**VALUE ENGINEERING SUMMARY
OF
US 119/BENT MT. TO COBURN MT.
WPI NO. 12-264.01
PIKE COUNTY, KENTUCKY**

DECEMBER 5-13, 1996

**Prepared by:
Ventry Engineering**

**Kentucky Transportation Cabinet,
Department of Highways**

*AT-GRADE INTERSECTION
STA. 24+950 I*

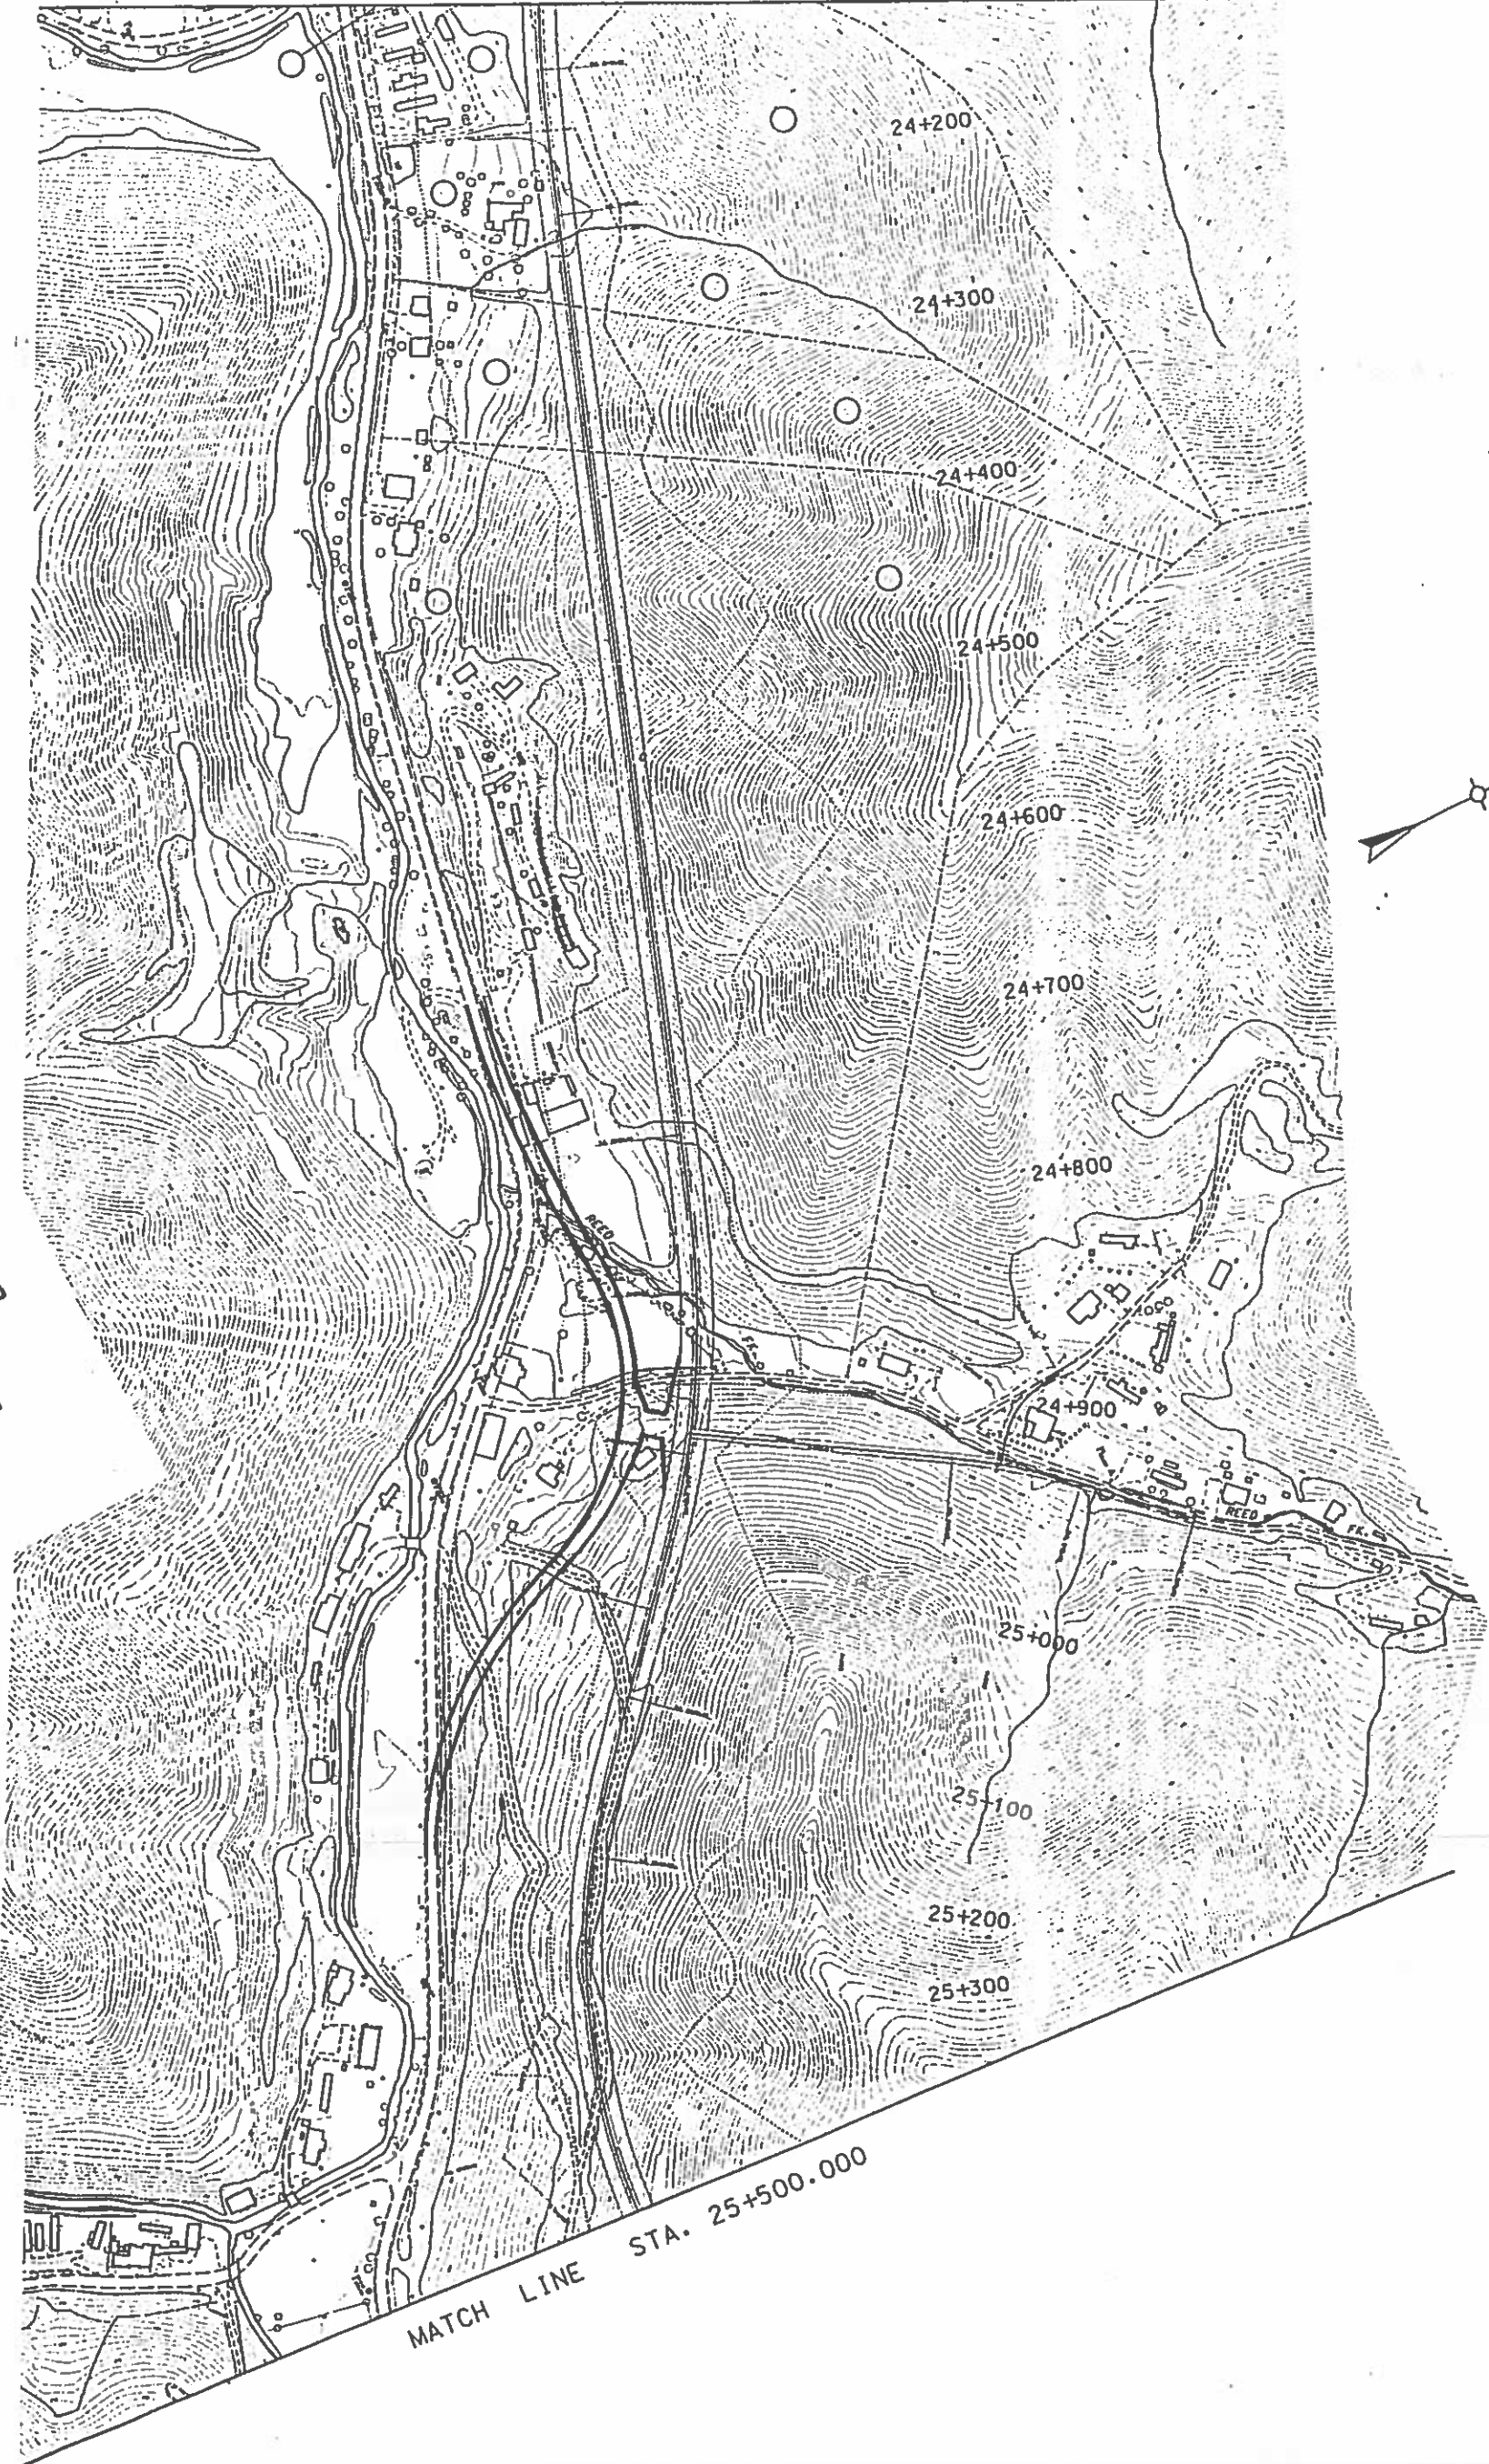
An additional at-grade intersection is being added at sta. 26 + 920 on the east end of the project. Both crossing will require extensive reconstruction of existing U.S. 119 in order to ramp up to the new mountain alignment. The differential grades requires a 500 + meter roadway to be constructed at 8% grades to bring the local traffic up to the new four lane section. The consultant provided a verbal description of the configuration of the intersection at the end of the job. The V.E. team then approximated the right-of-way impacts, fill volumes and pavement areas. The total dollars saved if both intersections were eliminated would be \$1,490,000.

The value engineering alternative is a grade separation interchange at approximately station 24 + 000 ± which would eliminate the two at-grade connectors at station 21 + 965.552 and sta. 29 + 200 ±. This interchange would require a single span bridge with four ramps. The approach embankments will require retaining walls on each side to allow placement of the ramps. Approximately 120 meters of roadway will be necessary to connect the existing U.S. 119 to the proposed alignment.

SPLIT CONCEPT
 1 of 2
 VALUE ENGINEERING
 ALTERNATIVE

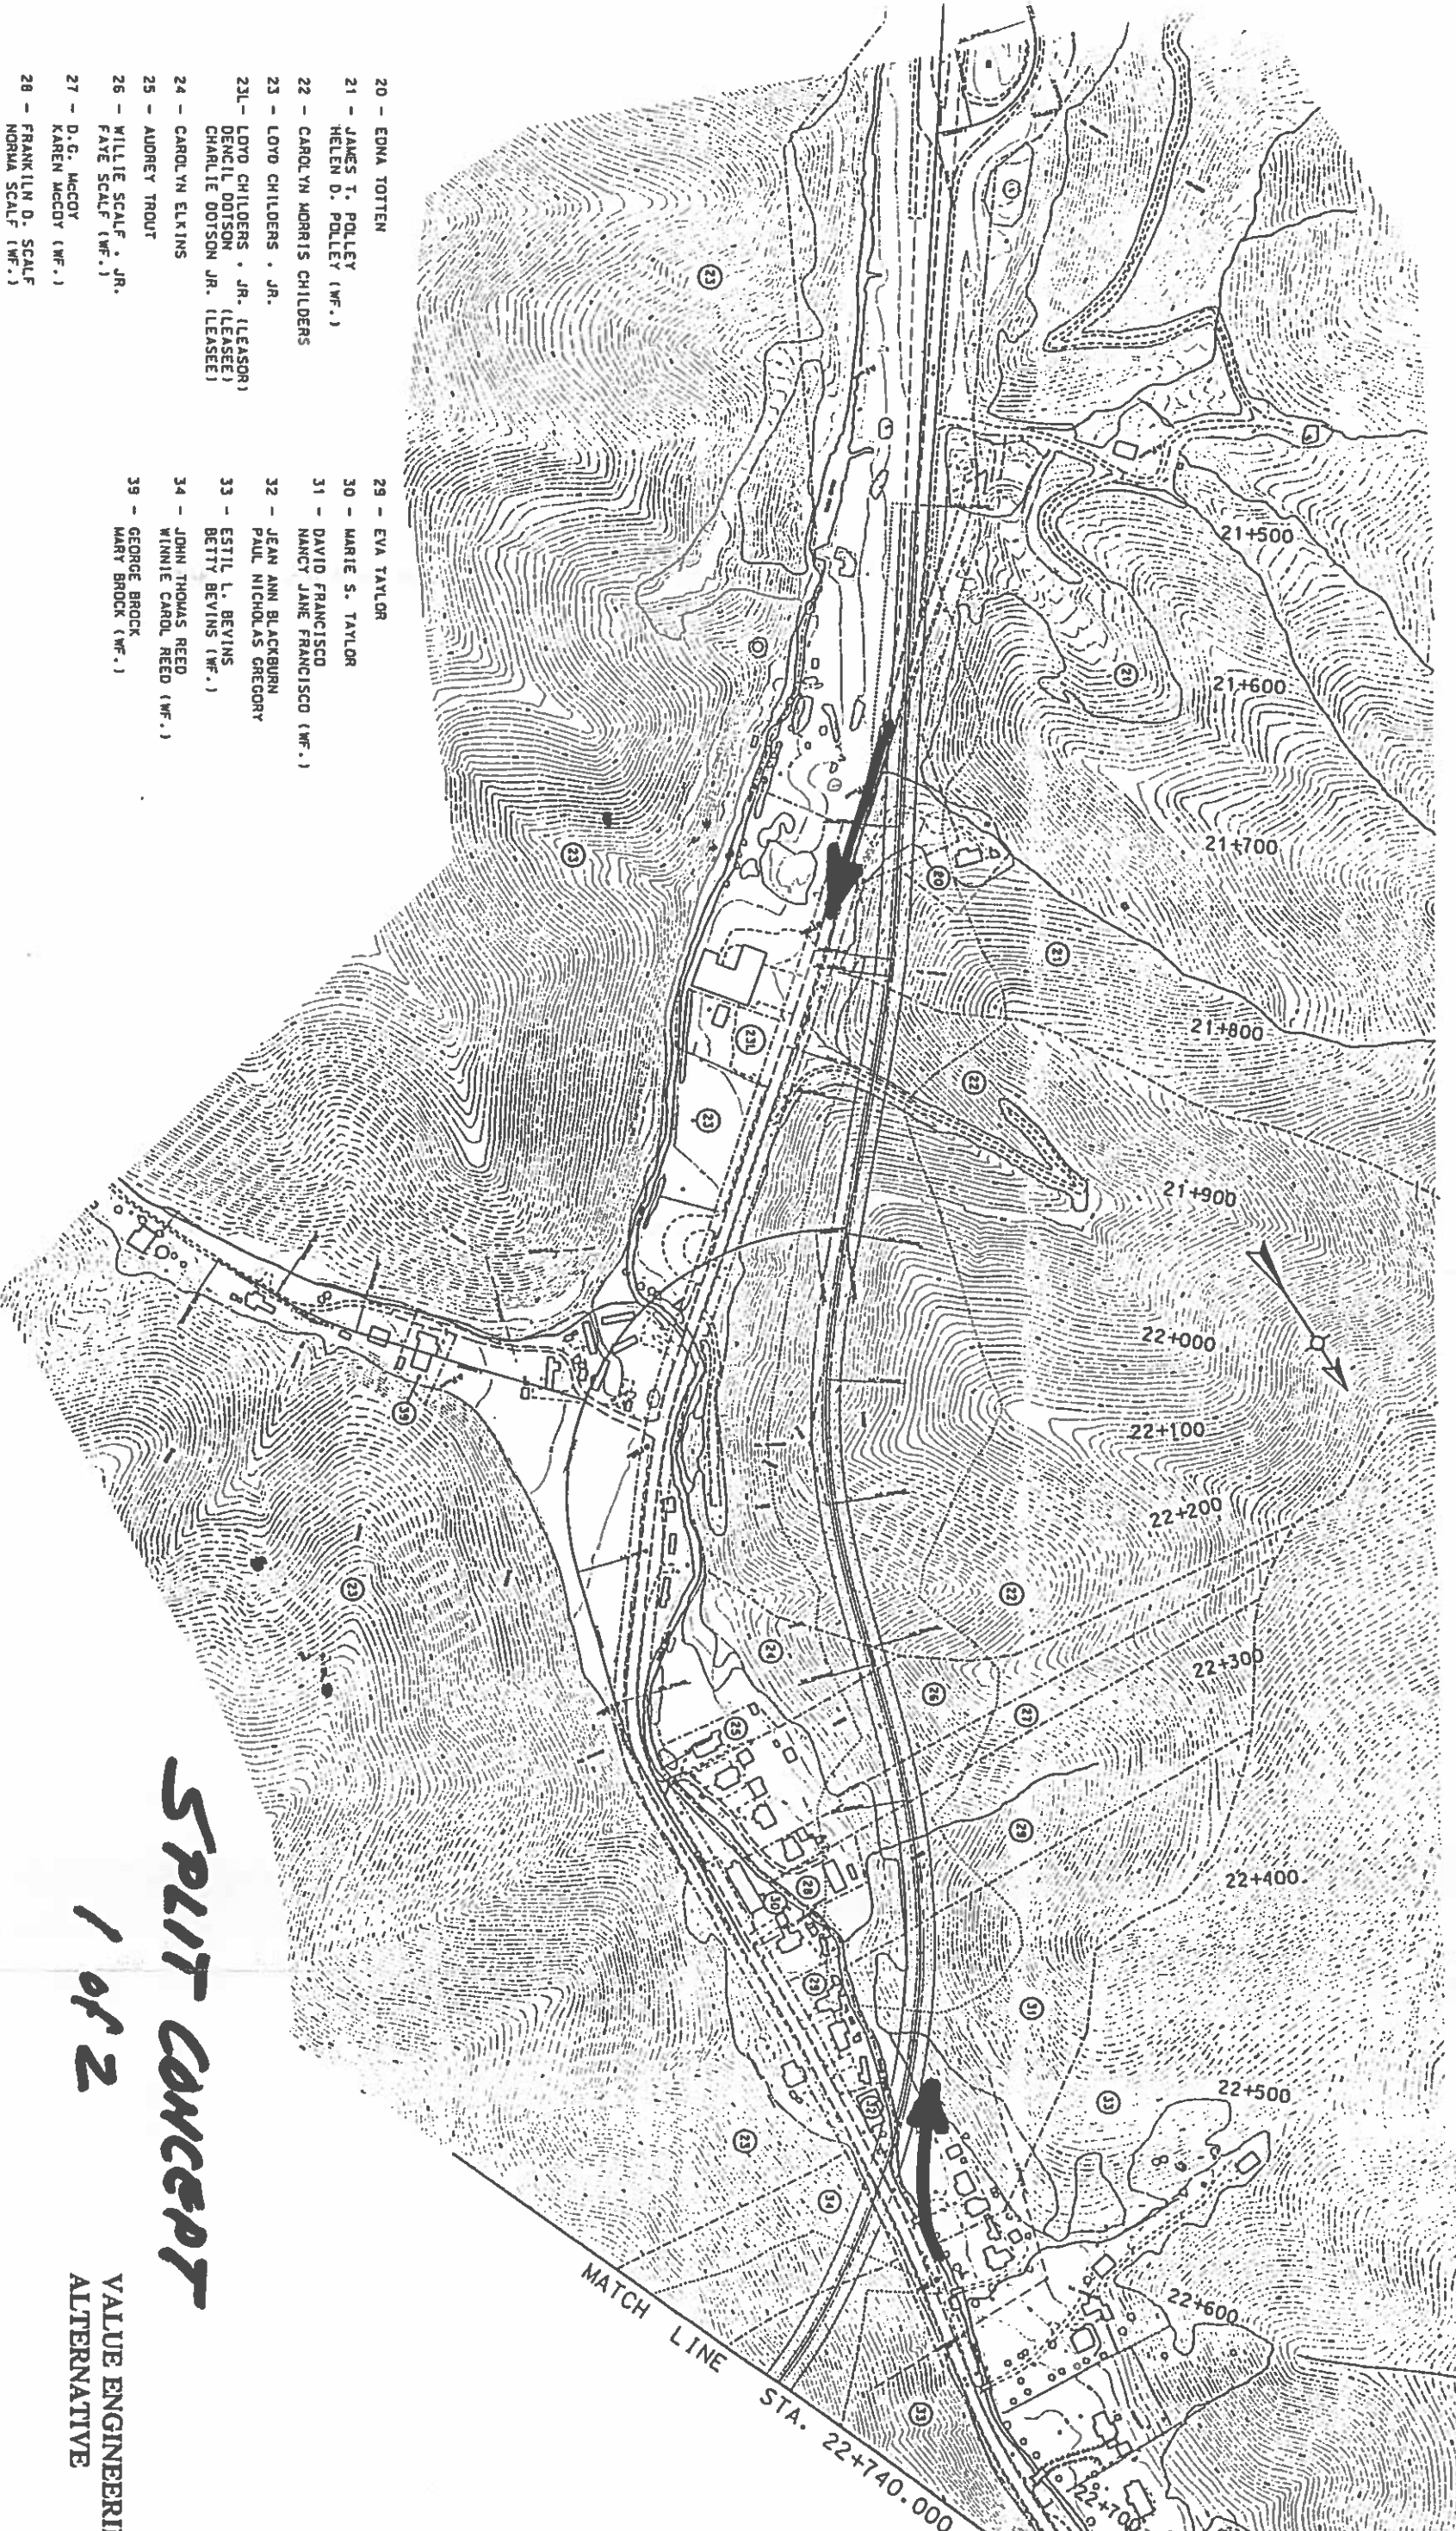
The team felt the ability to utilize the existing grade separations should offer an economical solution. During the evaluation phase this split concept dropped out as a result of the matrix evaluation. This was not carried forward to the development phase. During the presentation it was noted that the split concept interchange with the northbound exit located at Sta. 21 + 600; southbound entrance located at Sta. 22 + 500; and northbound entrance and southbound exit at Sta. 23 + 050, may have strong possibilities. This concept would require one additional structure for the SB on-ramp over Road Fork Creek at sta. 21 + 600. The grades as depicted upon first glance are workable with the southbound entrance ramp needing some acceleration lane requirements.
